# UNITED STATES PATENT AND TRADEMARK OFFICE

APPLICATION NO.	FILING DATE	FIRST NAMED INVENTOR	ATTORNEY DOCKET NO.	CONFIRMATION NO.
10/643,878	08/20/2003	Kevin T. Foley	2165.0010003	5214
5514 7590 11/29/2007 FITZPATRICK CELLA HARPER & SCINTO 30 ROCKEFELLER PLAZA NEW YORK, NY 10112			EXAMINER RAMANA, ANURADHA	
			ART UNIT 3733	PAPER NUMBER
			MAIL DATE 11/29/2007	DELIVERY MODE PAPER

# Office Action Summary

## **DETAILED ACTION**

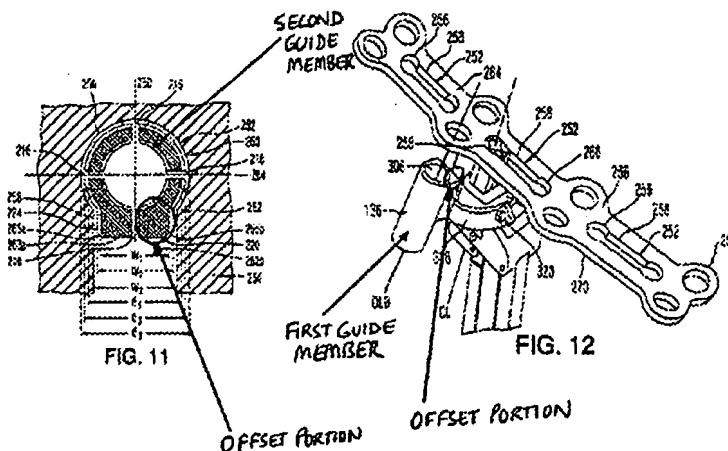
Claims 1-4, 7-11, 27 and 28 are rejected under 35 U.S.C. 103(a) as being unpatentable over Brace et al. (US 6,342,057) in view of Oxland et al. (US 5,676,666).

Brace et al. disclose a drill guide assembly for use with a bone plate to correctly seat screws in the bone plate, the assembly including: a first guide member 136 and a second guide member 206 extending from a handle 126; each of the guide members having an offset portion adjacent a distal end of the guide member; each of the guide members having a main body portion of a first width, an intermediate portion having a second width less than the first width, and the slot engaging end having a third end less than the second width; and wherein the guide members are configured and dimensioned to fit bone plate fastener holes having an elliptical shape (Figs. 1-2, 6 and 10-12 and cols. 5, lines 19-67 and cols. 6-14). See marked up Figs. 11 and 12 from Brace et al. below.

Brace et al. disclose all elements of the claimed invention except for a bone plate having fastener holes with an elliptical shape.

noted that edges 265a and 265b of the offset portions of Brace et al. are configured to contact an end of the slot (see Fig. 12). Notwithstanding this, it is noted that the limitation, "configured to contact said first end of said corresponding slot" only requires the capability of the offset portions to contact the first end of the slot and is not a positive limitation and does not constitute a limitation in any patentable sense.
